PrairieIslandNPEm Resource

L-PI-09-030
10 CFR 54

Prairie Island Nuclear Generating Plant Units 1 and 2
Dockets 50-282 and 50-306
License Nos. DPR-42 and DPR-60

Responses to NRC Requests for Additional Information Dated February 20, 2009 and
Follow Up Questions Regarding Application for Renewed Operating Licenses

Prairie Island Unit 1 Cumulative Heatup and Cooldown Cycles

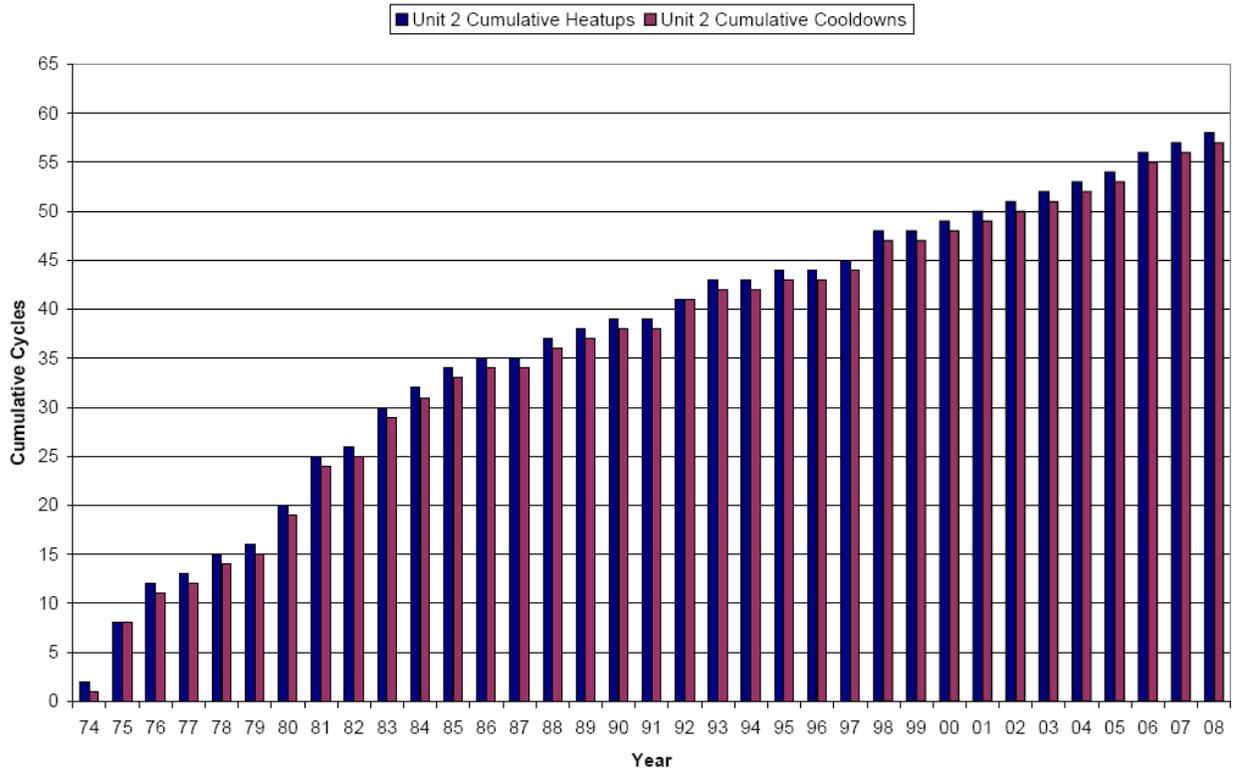
- (a) Please describe the procedures that PINGP has been using for tracking thermal activities so the staff can confirm that the PINGP aging management program will ensure that P-T characteristics, including their values, ranges, and rates remain bounded within the range defined in the design specifications during the renewed license term.
- (b) Please provide a histogram (cycle accumulating charts) of heatup transient history, and a histogram for the cooldown transient as well.

For heatups and cooldowns, the maximum hourly rate ($^{\circ}\text{F}/\text{hr}$) is recorded on the cycle summary sheet for each heatup and cooldown. A review of past plant heatup and cooldown data indicates that the average plant heatup rate has been approximately $40^{\circ}\text{F}/\text{hr}$ and the average plant cooldown rate has been about $70^{\circ}\text{F}/\text{hr}$. For design purposes, the transient parameters response for the heatup and cooldown transients is based on a rate of $100^{\circ}\text{F}/\text{hr}$. Therefore, the design transient responses remain bounding with respect to the actual plant heatup and cooldown rates.

Prairie Island Unit 1 Cumulative Heatup and Cooldown Cycles

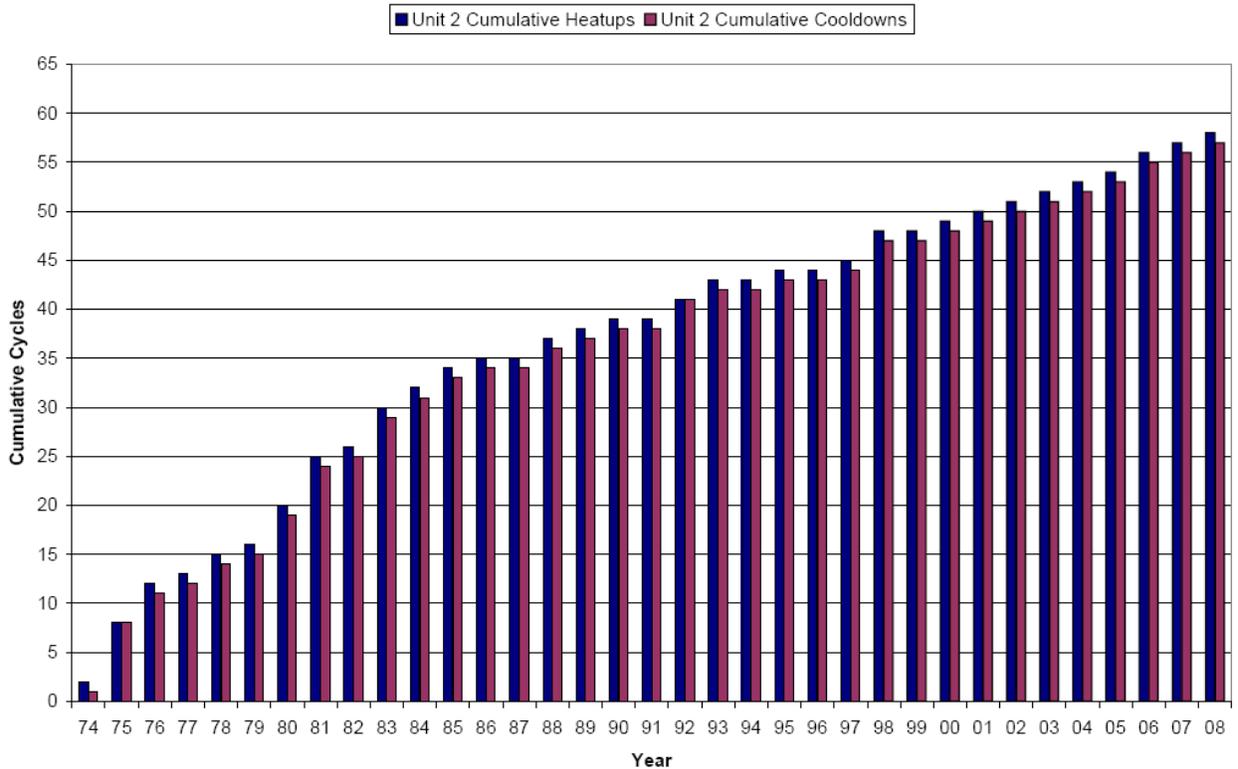
- (a) Please describe the procedures that PINGP has been using for tracking thermal activities so the staff can confirm that the PINGP aging management program will ensure that P-T characteristics, including their values, ranges, and rates remain bounded within the range defined in the design specifications during the renewed license term.
- (b) Please provide a histogram (cycle accumulating charts) of heatup transient history, and a histogram for the cooldown transient as well.

For heatups and cooldowns, the maximum hourly rate ($^{\circ}\text{F/hr}$) is recorded on the cycle summary sheet for each heatup and cooldown. A review of past plant heatup and cooldown data indicates that the average plant heatup rate has been approximately 40°F/hr and the average plant cooldown rate has been about 70°F/hr . For design purposes, the transient parameters response for the heatup and cooldown transients is based on a rate of 100°F/hr . Therefore, the design transient responses remain bounding with respect to the actual plant heatup and cooldown rates.
